ADDENDUM #04

DATE:	September 29, 2023	PROJECT NO.:	Project # 20229080 CRSA Project # 21-031
TO:	Gramoll Construction 155 S. 750 W. North Salt Lake, UT 84054	PROJECT:	Rio Grande Depot Seismic 300 S. Rio Grande St. SLC, UT 84101

This Addendum forms a part of the Contract Documents and modifies the original Bid Documents dated October 3, 2022 as noted below. Acknowledge receipt of this Addendum in the space provided on the Bid Form. Failure to do so may subject the Bidder to disqualification.

AE505

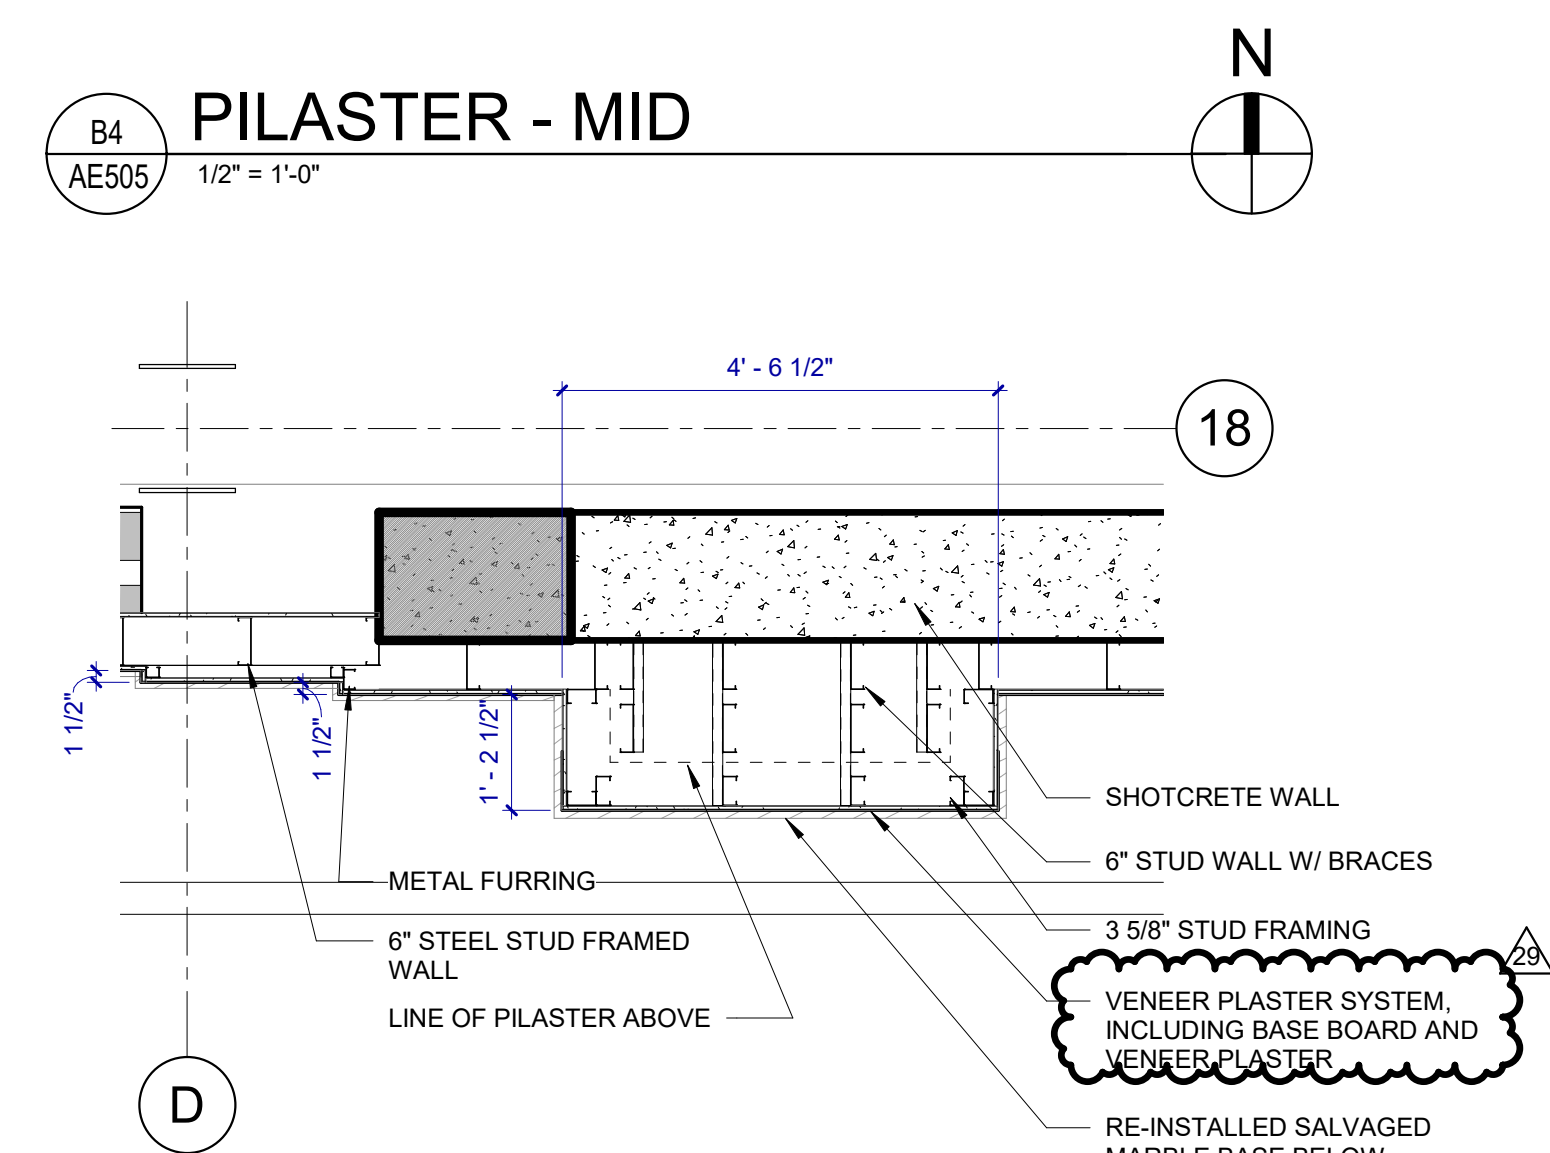
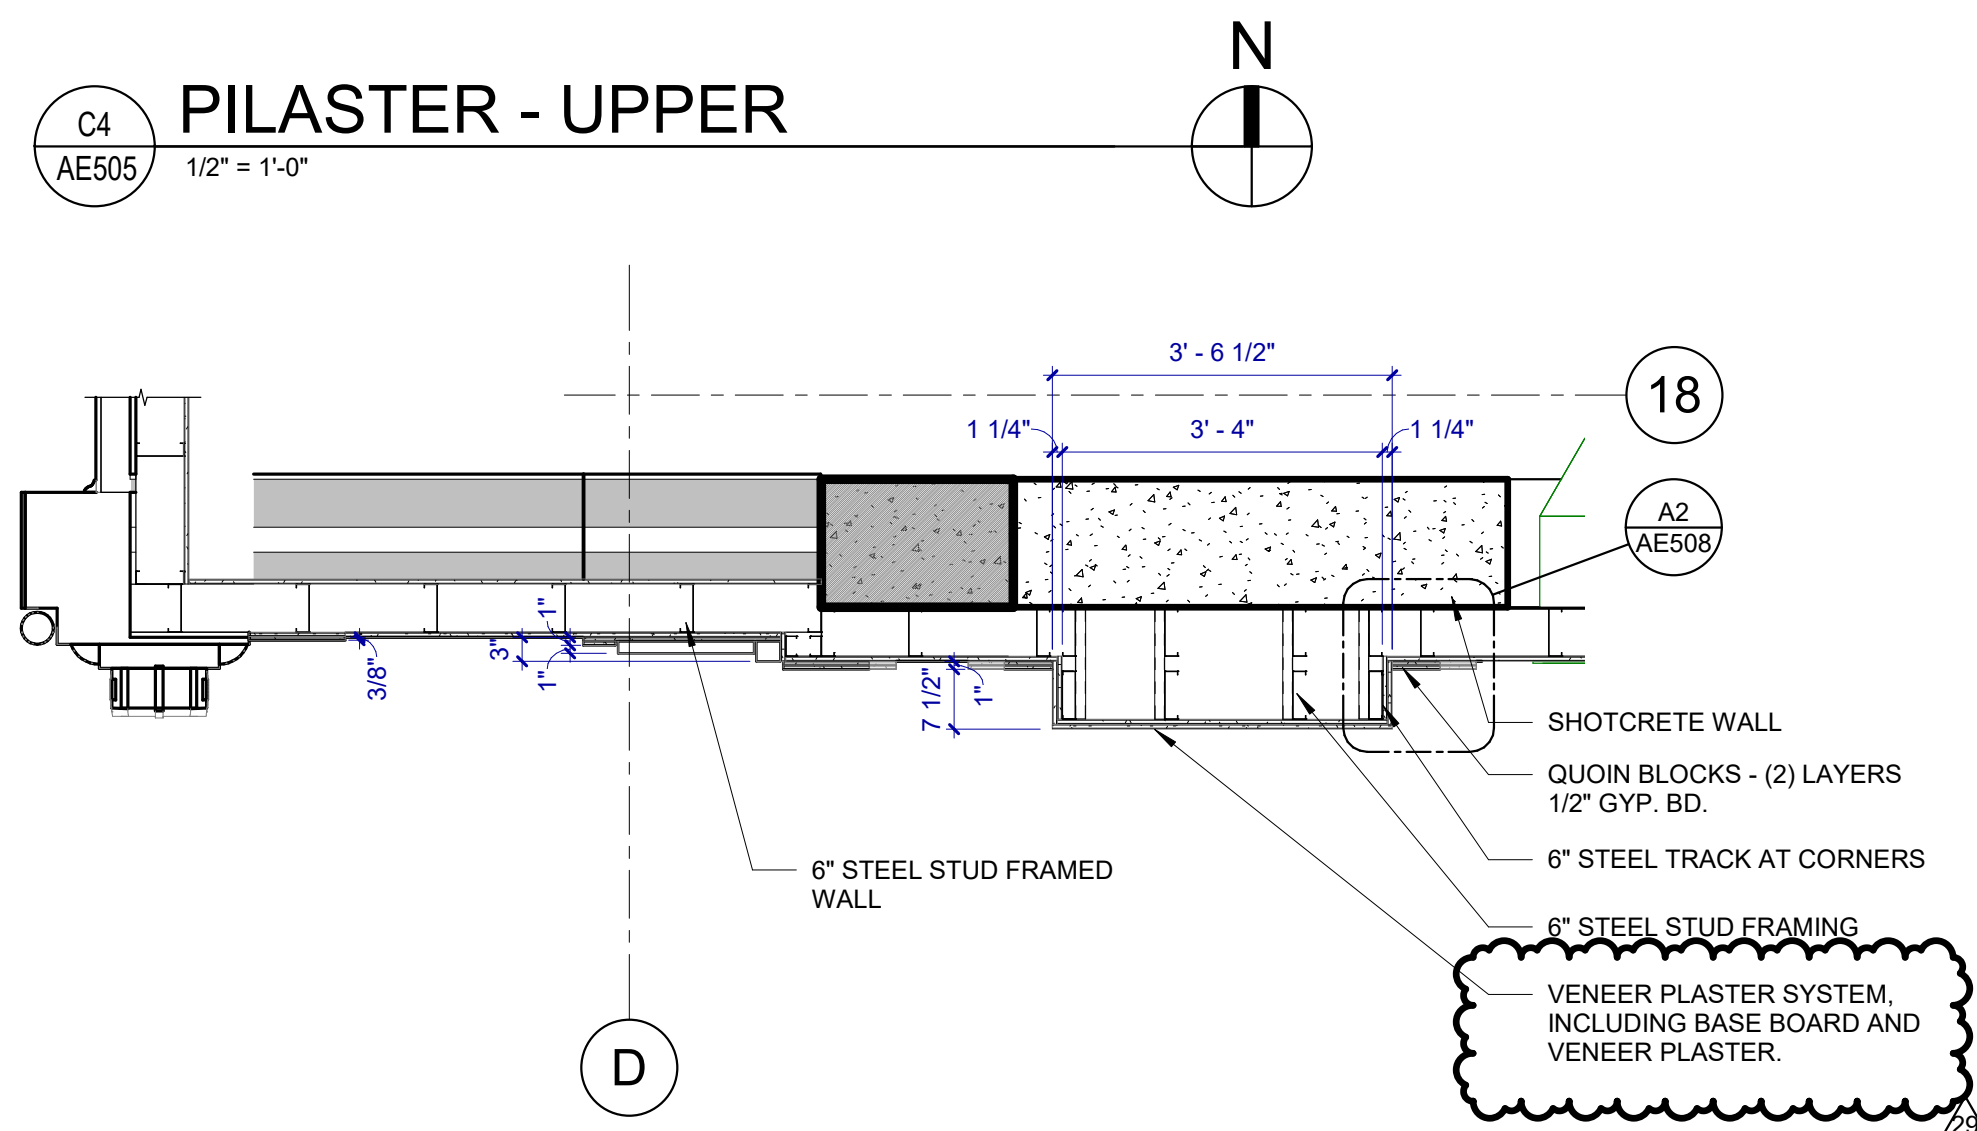
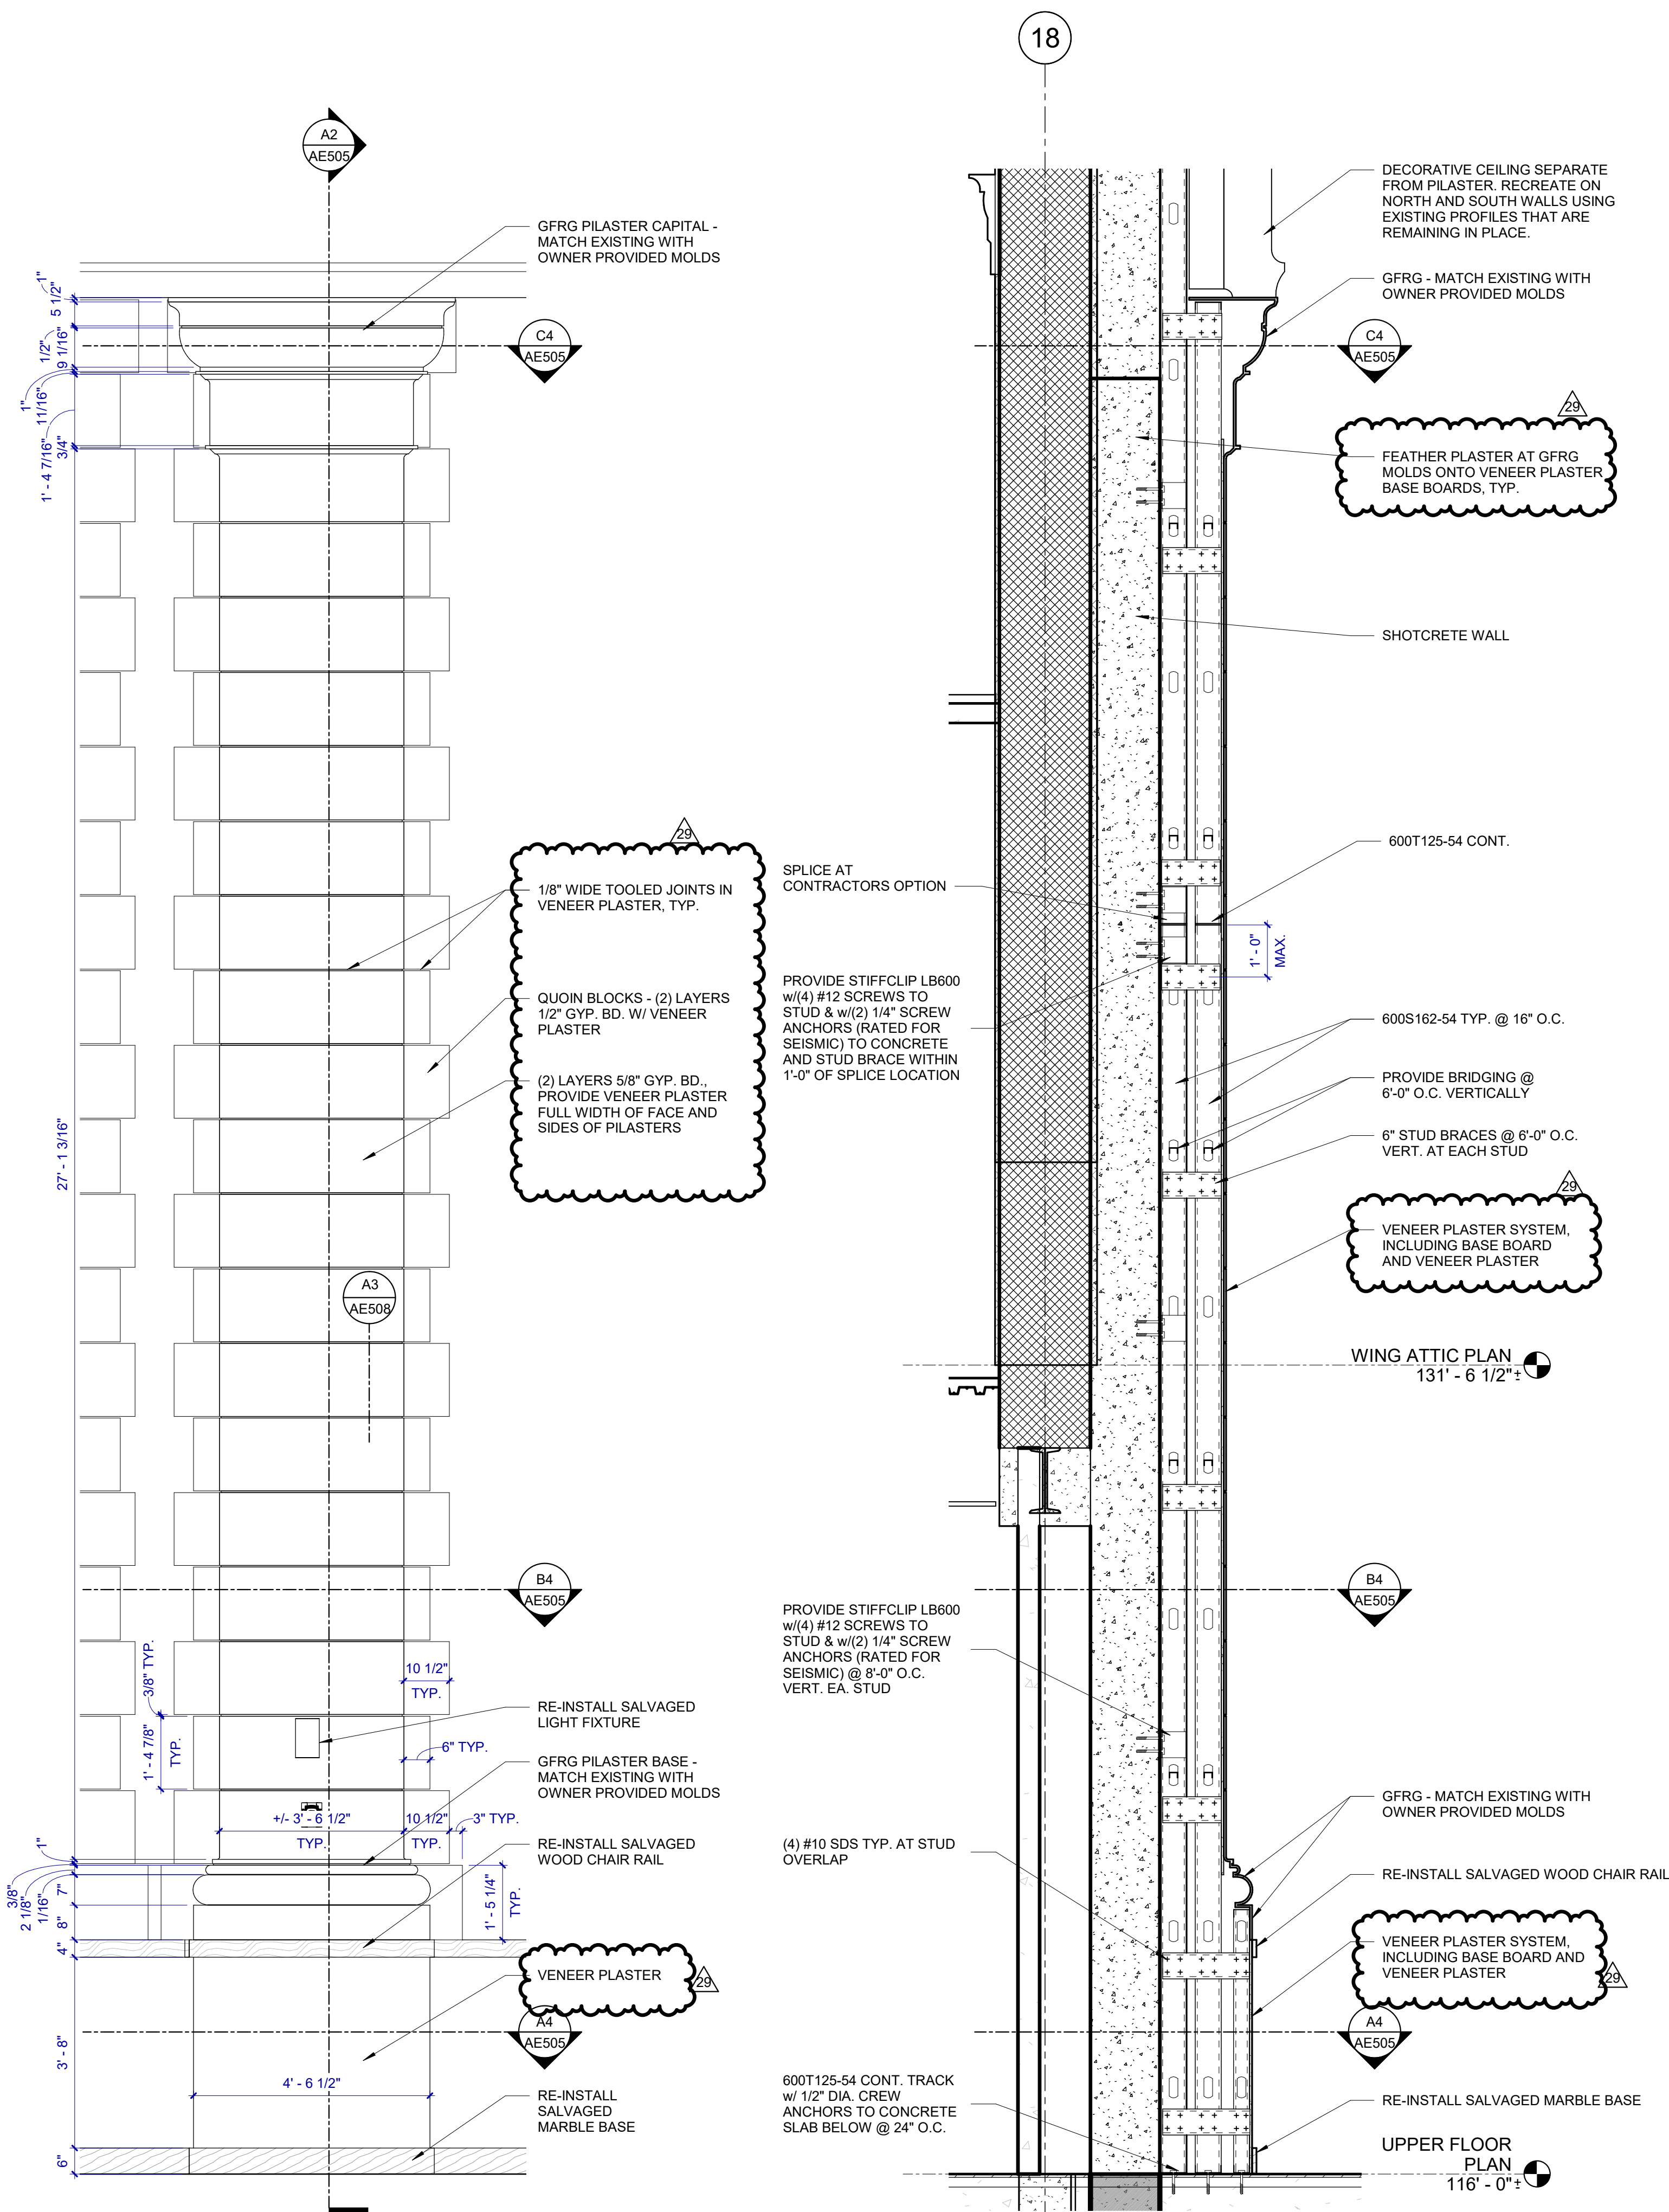
VI-6 AE505: Changed gyp board notes to veneer plaster system.

AE506

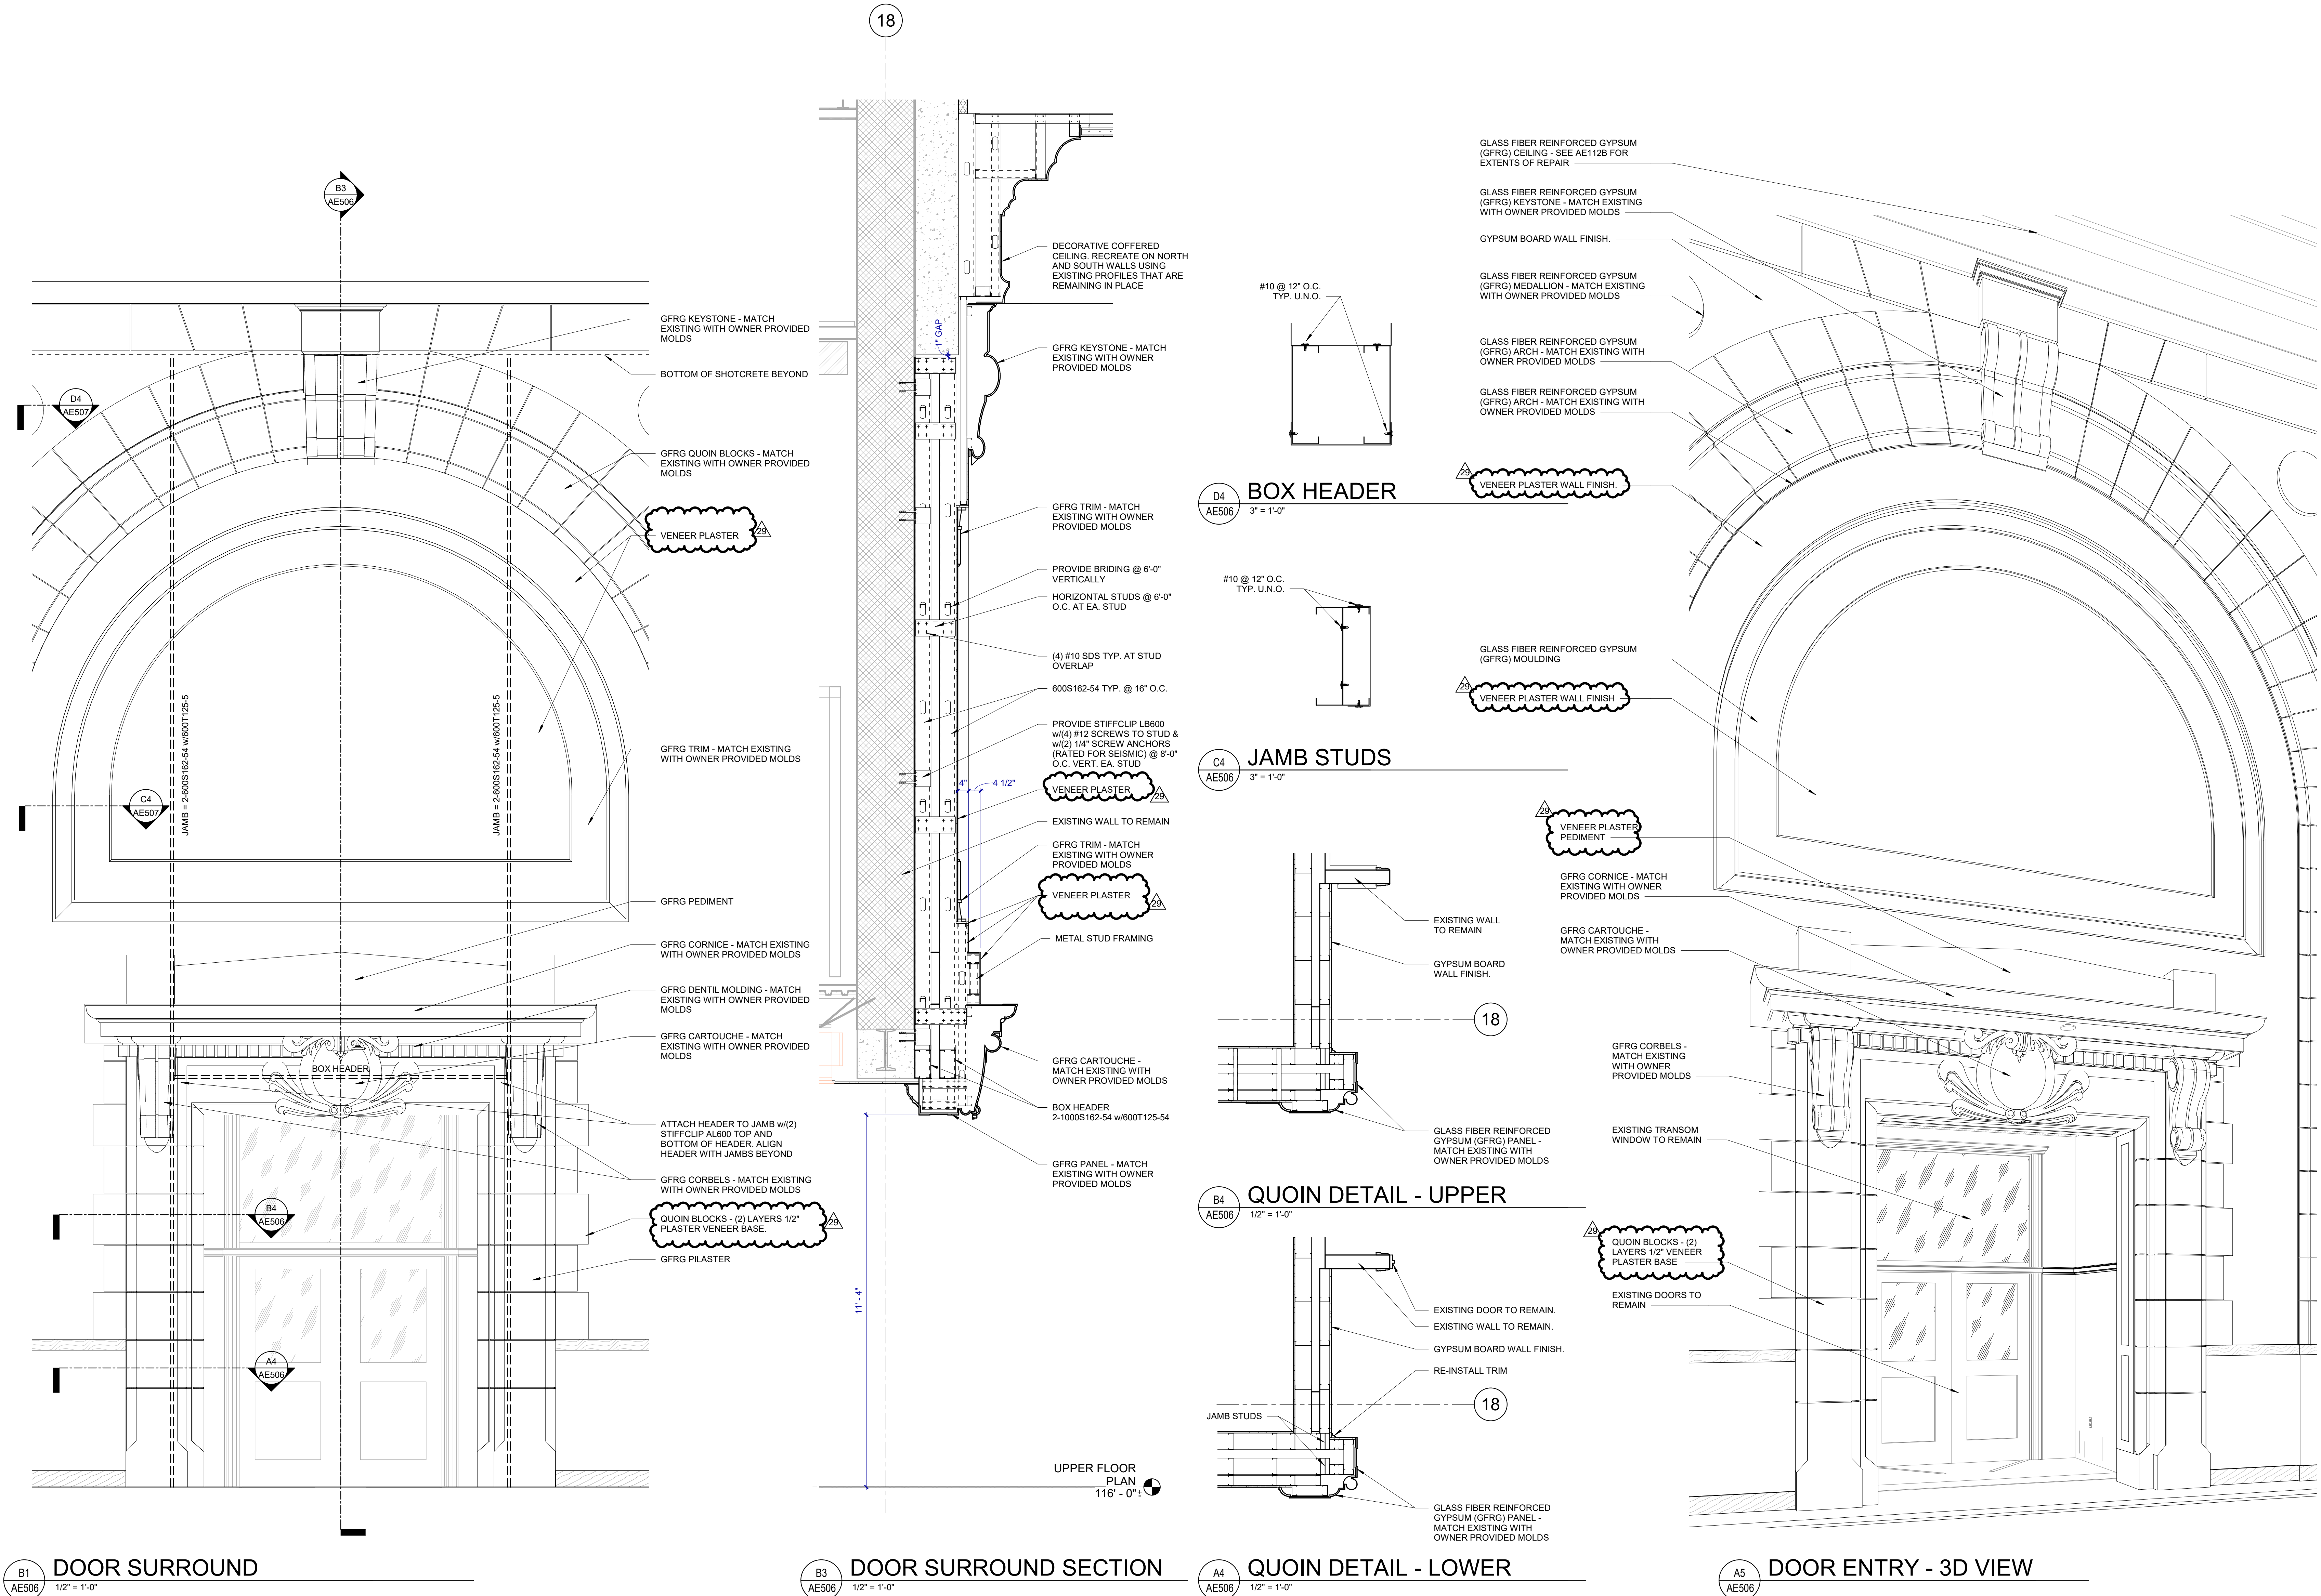
VI-7 AE506: Changed gyp board notes to veneer plaster system.
